FEI BERC RATE METHODOLOGY
EXHIBIT A-7

Re: FortisBC Energy Inc.
Application for Approval of Biomethane Energy Recovery Charge
Rate Methodology

Further to British Columbia Utilities Commission Order G-147-15, which established the Regulatory Timetable with respect to the above noted Application, enclosed please find the Commission's Information Request No. 2 to FortisBC Energy Inc. Please provide your written responses with the Commission at the Streamlined Review Process on Wednesday, February 3, 2016.

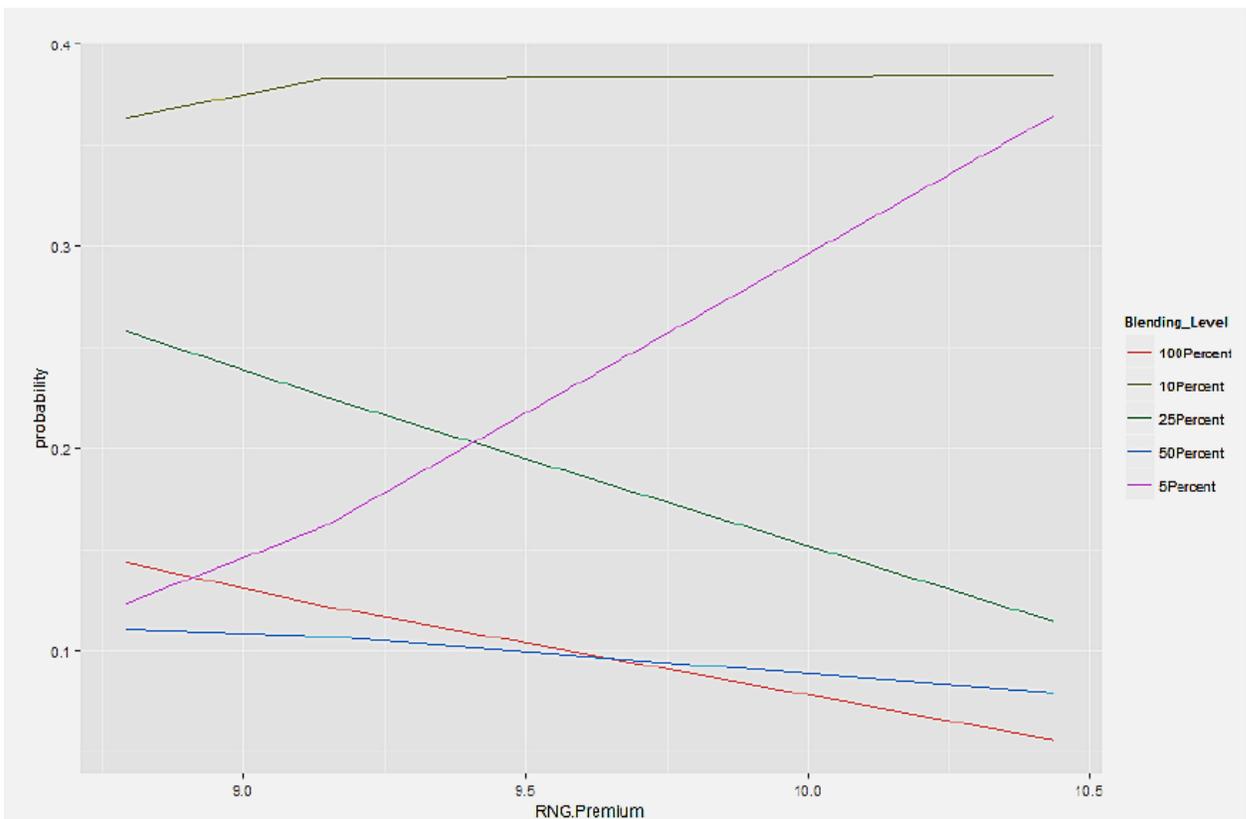
- 47.1 Please briefly explain the objectives and purpose of a multinomial regression, and why the multinomial regression is appropriate for the RNG demand curve and elasticity of demand. Why is a simple linear regression not appropriate in this case (e.g. using dummy variables)?

- 47.6 How should a negative average elasticity be interpreted, if any different compared to a positive average elasticity?
- 47.7 The proposed RNG premium is \$7 for short term contracts and \$6 for long term contracts. Why did FEI appear to choose an interval between \$8.50 and \$10.50 RNG Premium as shown in the graph in the preamble?

- 47.8 Please expand the graph with the “RNG Premium” axis with a minimum value of \$3 to a maximum value of \$12, and expand the “probability” axis from 0 to 1. If not possible, please explain why.

- 47.9 How does FEI interpret the multinomial regression results? Please provide interpretations for each blend level (i.e. 5 percent, 10 percent, 25 percent, 50 percent and 100 percent), for each \$1 increments from \$3 to \$12, with specific probability levels.

- 47.9.1 In the 5 percent blend case, FEI states that “a price increase beyond the \$10.50 per GJ RNG premium, customers are most likely to choose the 5 percent option over other options.” [Emphasis added]

Please specify the probability associated with “most likely”. Is it a 35 percent chance as indicated in the graph shown in the preamble? If not, please clarify.

47.9.2 Based on FEI’s interpretation, in the 5 percent blend case, is it true to say that a price decrease below the \$9/GJ RNG premium, customers would have around 10 percent probability chance to stay in the 5 percent option? If not, please clarify.

47.10 A traditional demand curve shows price on the y-axis and quantity on the x-axis. Please provide a demand curve with RNG Premium (price) on the y-axis and blend level (quantity) on the x-axis. If not possible, please explain why.
